CITY PLAN COMMISSION**THURSDAY, JUNE 25, 2026****FILE NUMBER:** PLAT-26-000134**SENIOR PLANNER:** Sharmila Shrestha**LOCATION:** Cedardale Road, north of Lyndon B Johnson Freeway**DATE FILED:** May 27, 2026**ZONING:** PD 761 (LR)**PD LINK:** <https://dallascityhall.com/departments/city-attorney/pages/articles-data.aspx?pd=761>**CITY COUNCIL DISTRICT:** 8**SIZE OF REQUEST:** 19.85-acres**APPLICANT/OWNER:** Longhorn Truck Center, LLC**REQUEST:** An application to create one 19.85-acre lot from a tract of land in City Block 8264 on property located on Cedardale Road, north of Lyndon B Johnson Freeway.**SUBDIVISION HISTORY:**

PRELIMINARY PLAT

LONGHORN TRUCK CENTER @ CEDARDALE

PRELIMINARY PLAT

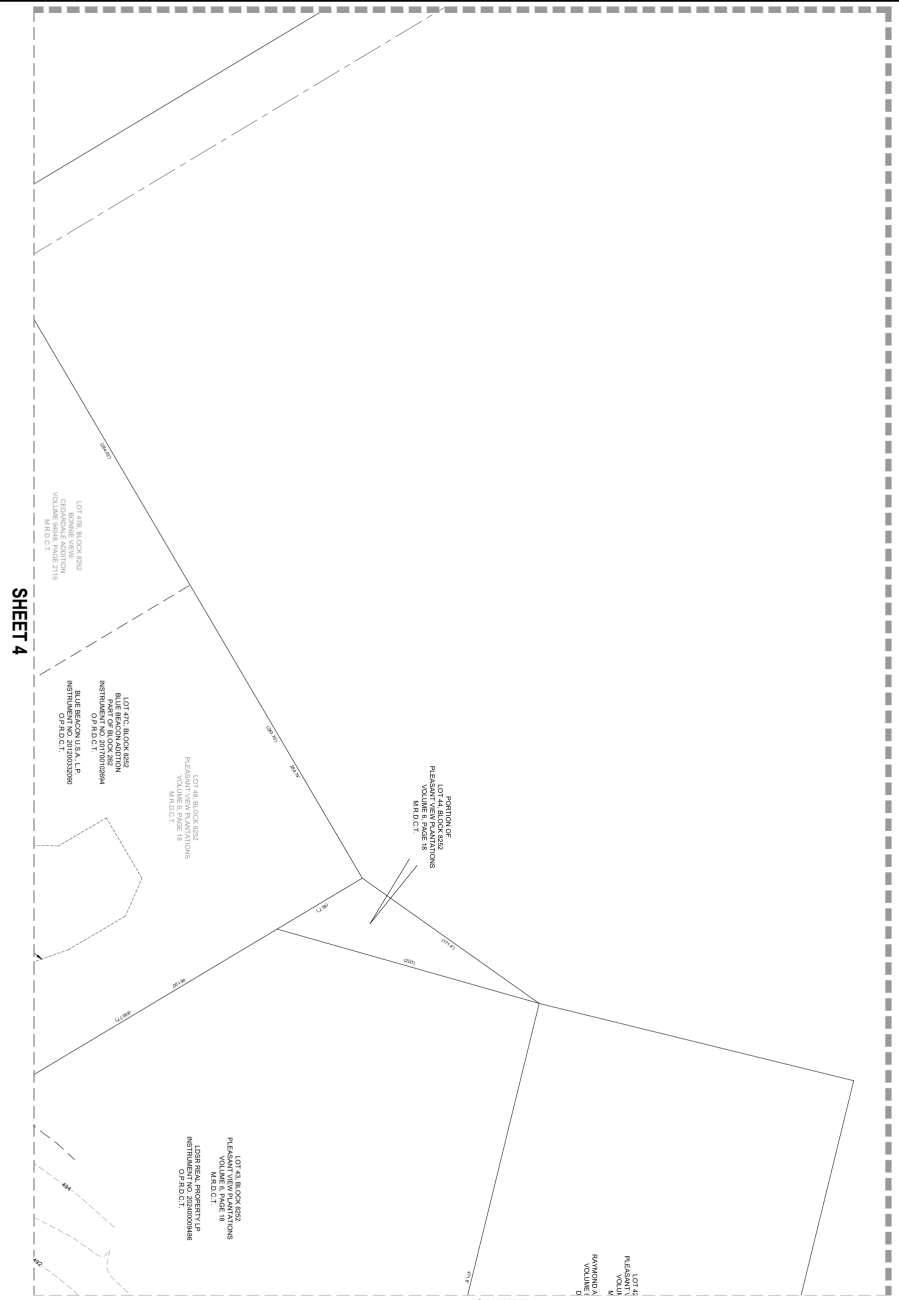
24. Prior to final plat, submit a completed final plat checklist and all supporting documents.
25. On the final plat, show recording information on all existing easements within 150 feet of the property.
26. Remove building line(s) from plat.
27. Clarify Volume 89132, Page 2152 and Volume 89132, Page 2175, Deed Records, Dallas County, Texas.
28. Clarify survey line locations.

33. Plans must comply with City's street lighting standards. See illumination standards in Street Design Manual.
34. On the final plat, change "Cedardale Road (Old Dncanville-Wheatland)" to "Cedardale Drive (FKA Old Duncanville-Wheatland Road)."
35. On the final plat, add "Bonnie View Road."
36. On the final plat, change "Lyndon B. Johnson Freeway (Interstate Highway 20 & Interstate Highway 635)" to "Lyndon B. Johnson Freeway/ Interstate Highway No. 20."
37. On the final plat, identify the property as Lot 3 in City Block A/8264.
